THM 4L60-E/4L65-E "UPDATE HANDBOOK"

AUTOMATIC TRANSMISSION SERVICE GROUP

THM 4L60-E/4L65-E

Figure 1

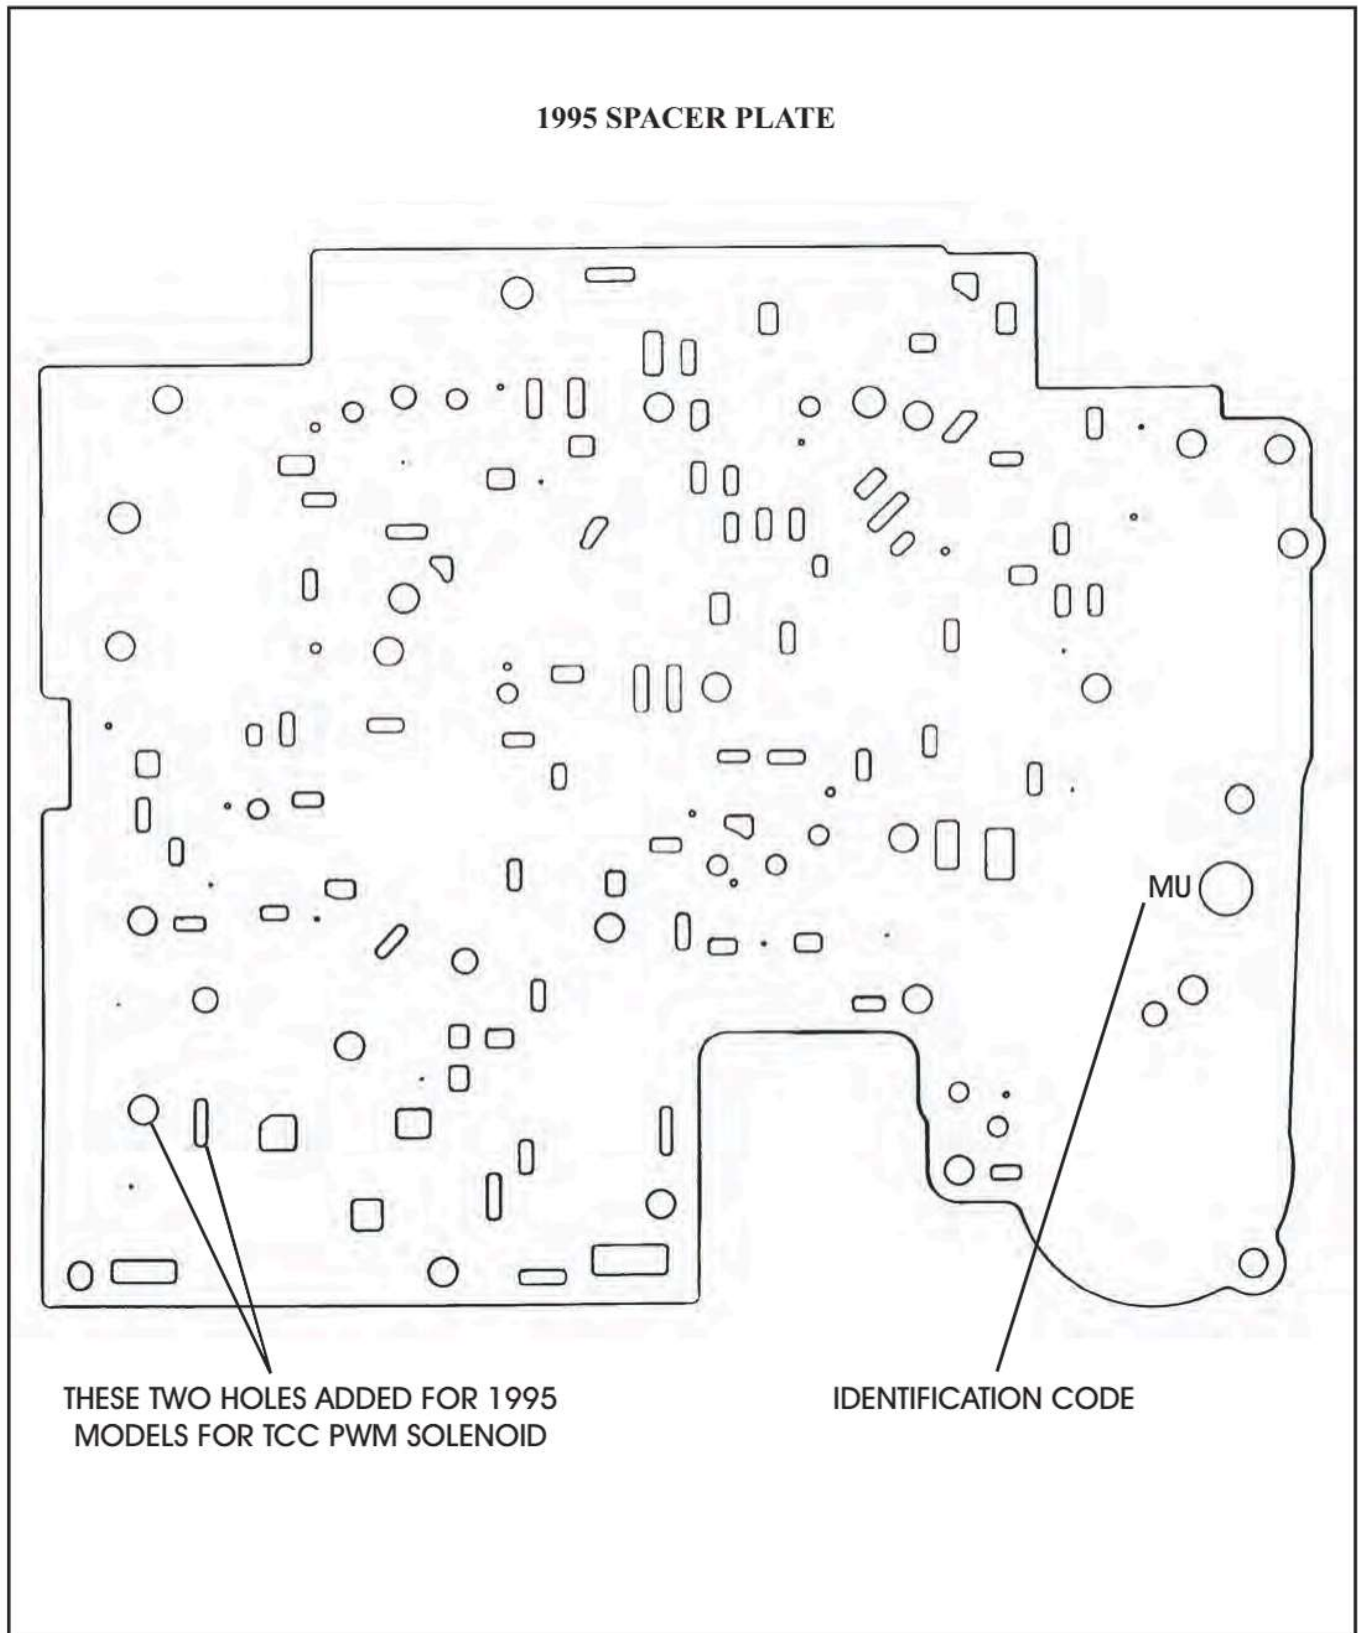
- (1) **VALVE BODY CASTING** - 1995 models are now machined to accept the added TCC PWM Solenoid, as shown in Figure 1. The added TCC PWM Solenoid is exactly the same and will interchange with the 3-2 downshift solenoid (See Figure 1).

Figure 3

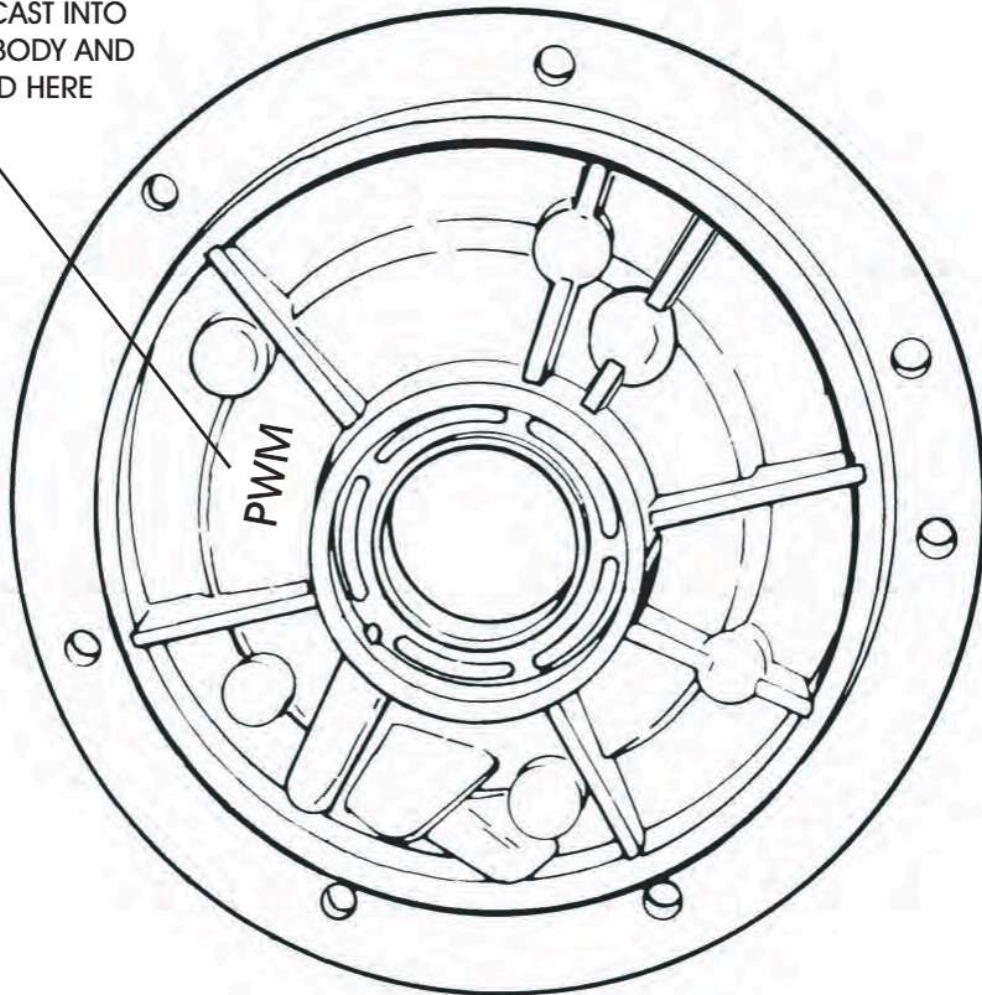
- (3) **OIL PUMP BODY** - There were changes in the worm track configuration on the new design pump body to accommodate the added TCC PWM solenoid. The pump body can be easily identified with "PWM" cast into the pump body, in the location shown in Figure 4. Refer to Figure 3 for the differences in the worm track area, which we have shaded for easy reference.

Figure 5

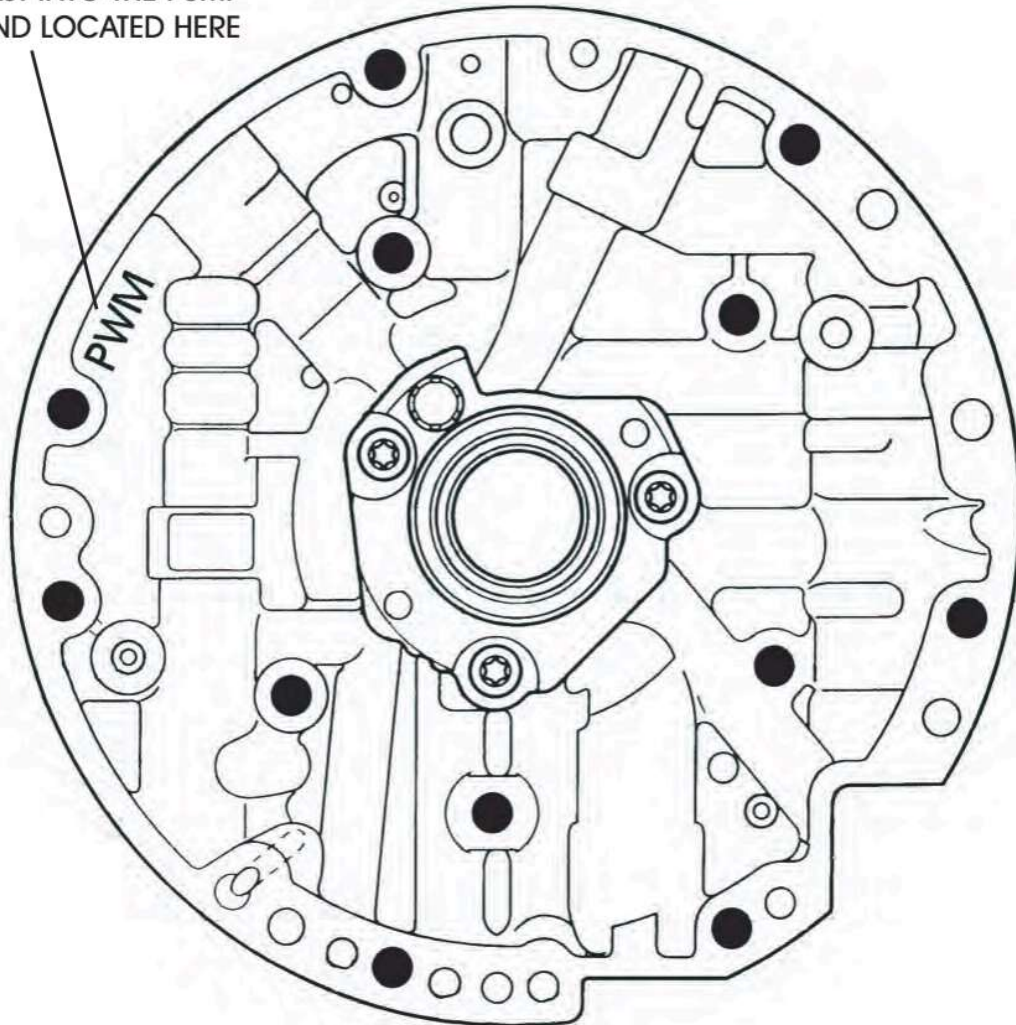
- (4) **OIL PUMP COVER (STATOR)** - There were changes in the worm track configuration on the new design pump cover to accommodate the added TCC PWM solenoid. The pump cover can be easily identified with "PWM" cast into the pump cover, in the location shown in Figure 6. Refer to Figure 5 for the differences in the worm track area, which we have shaded for easy reference.

Figure 1

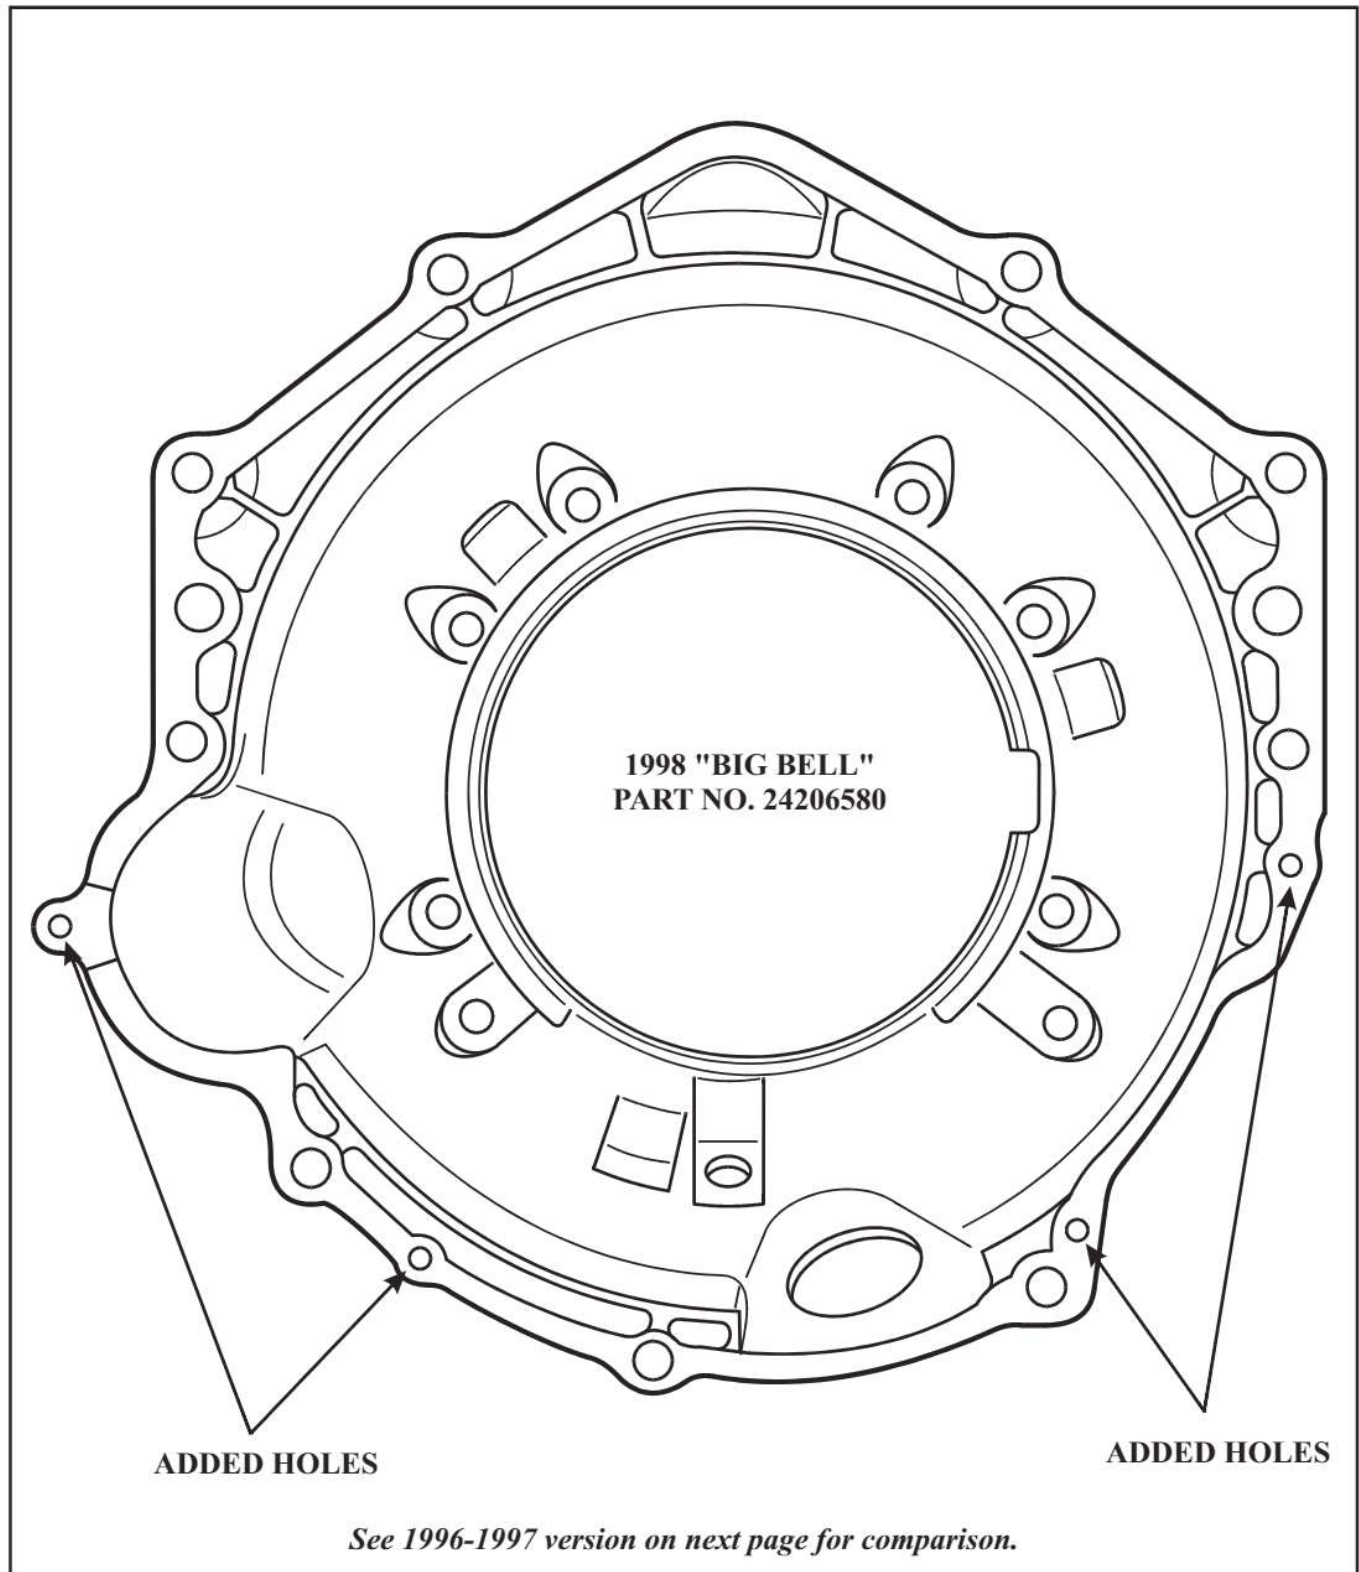
The Bellhousing shown in Figure 1, is approximately 1/4" deeper than the previous "Big Bell" and is designed to accommodate a new 300mm converter that is used in the 1998 Firebird and 1999 C & K Trucks. The best identification is the added bolt hole at the top of the bellhousing. This style bellhousing and the 300mm converter also require a new design turbine shaft and stator shaft that are also about 1/4" longer.

This style bellhousing and the 300mm torque converter also require a new design turbine shaft and stator shaft that are approximately 1/4" longer than other models.

Figure 2

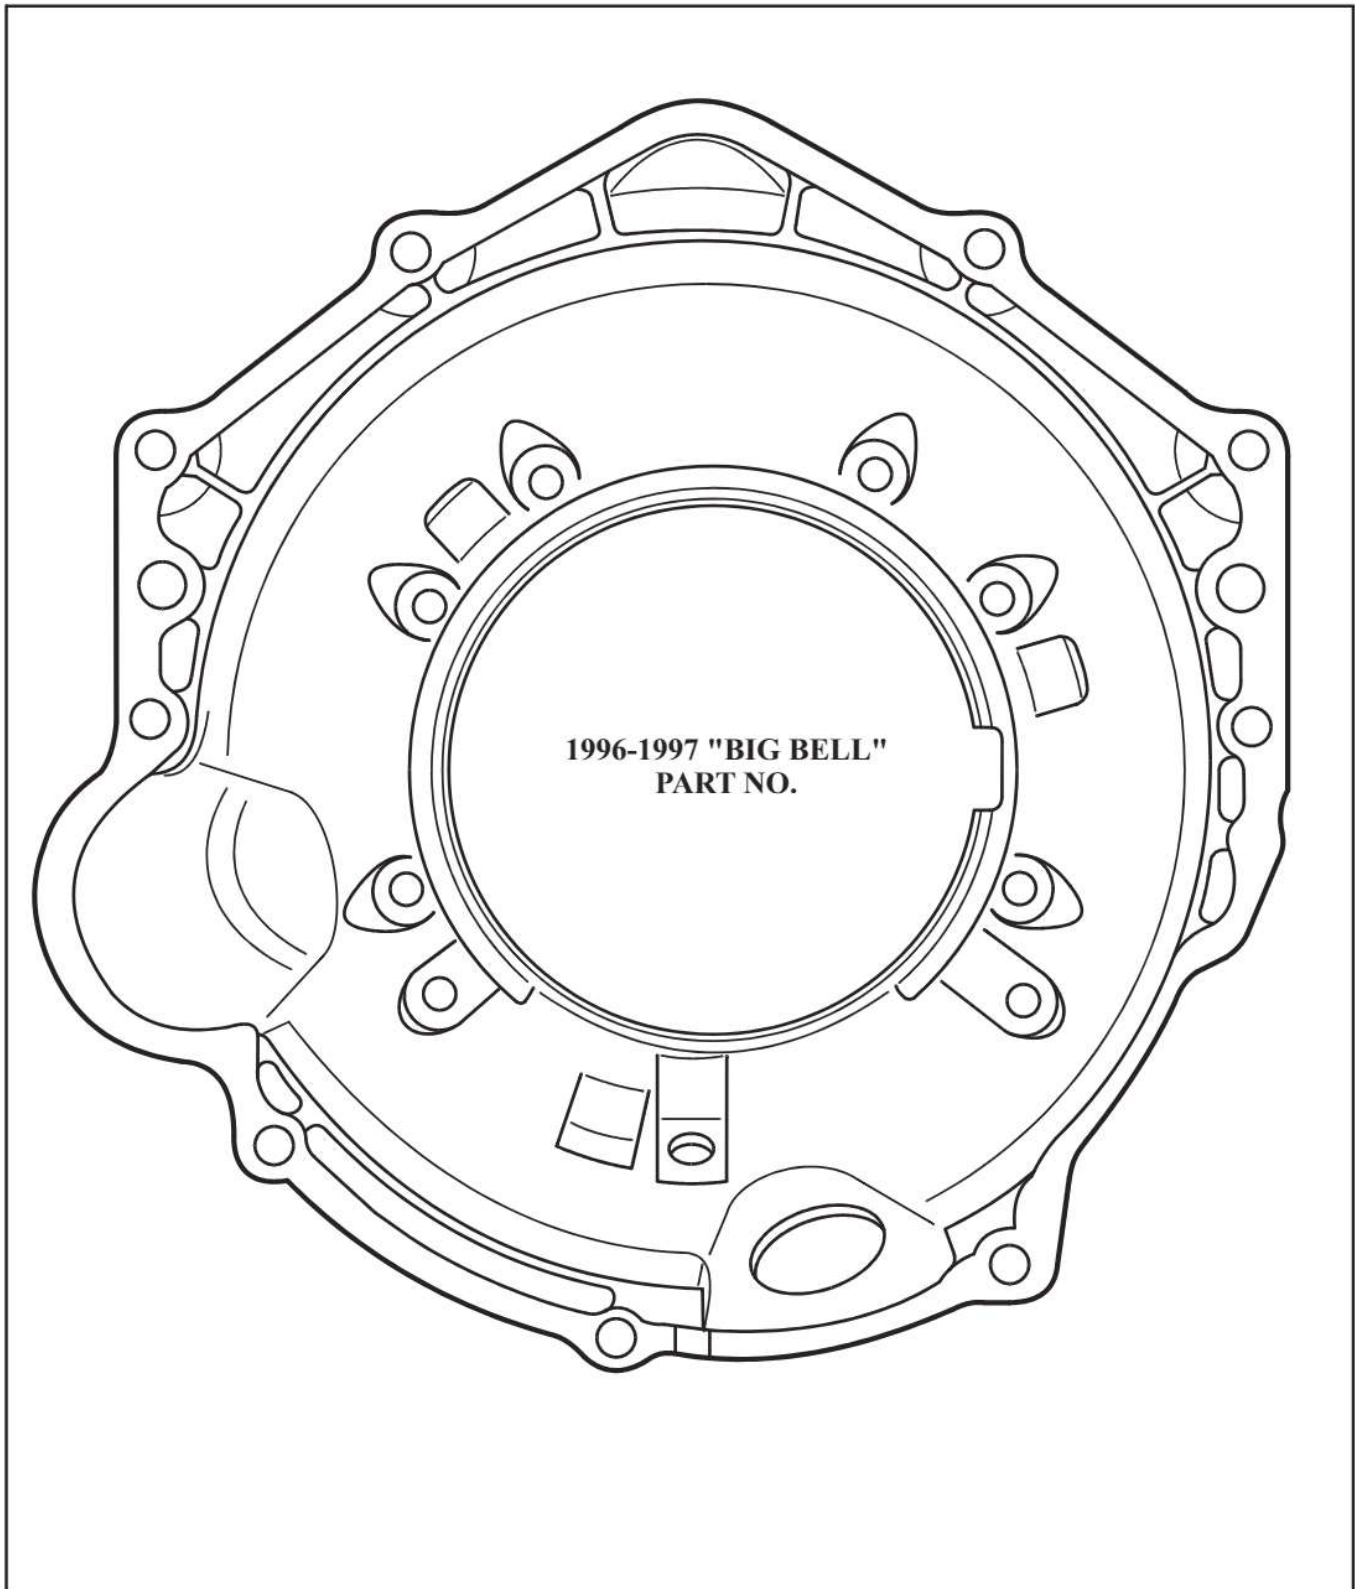
The Bellhousing shown in Figure 2, has four added holes for an added dust shield, and can be compared with the previous model "Big Bell" that is shown in Figure 3.

**13 VANE PUMP ROTOR AND SLIDE
FOR 1997 MODELS**

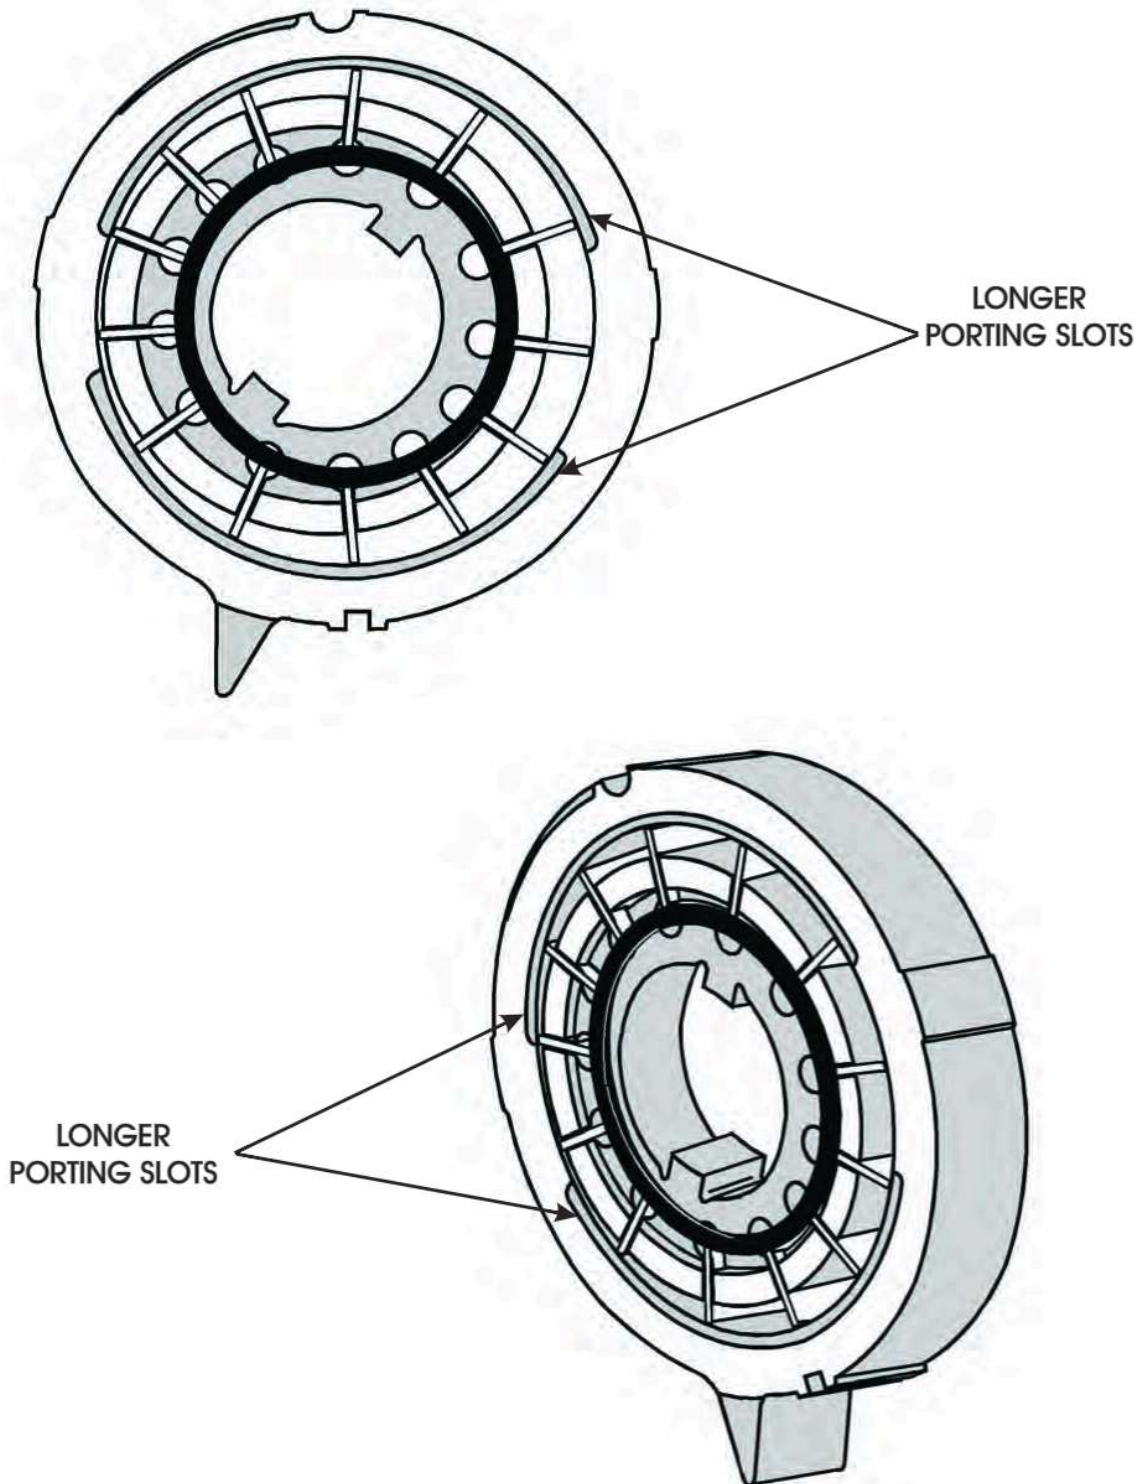
- (1) OIL PUMP ROTOR - Now has 13 vanes in the pump rotor instead of the previous 10 vanes, as shown in Figure 1.
- (2) OIL PUMP SLIDE - Now has longer porting slots on the face of the slide (See Figure 1).
- (3) ROTOR GUIDE - Now has 13 slots in the rotor guide to accommodate the added vanes.
- (4) OIL PUMP COVER - Now has different configuration on the porting slots in the pump cover to accommodate the changes in the pump slide (See Figure 2). The 13 vane pump cover can be easily identified with "13 V" cast into the back side in the location shown in Figure 3.
- (5) VANE RINGS - Material change to increase vane ring durability.
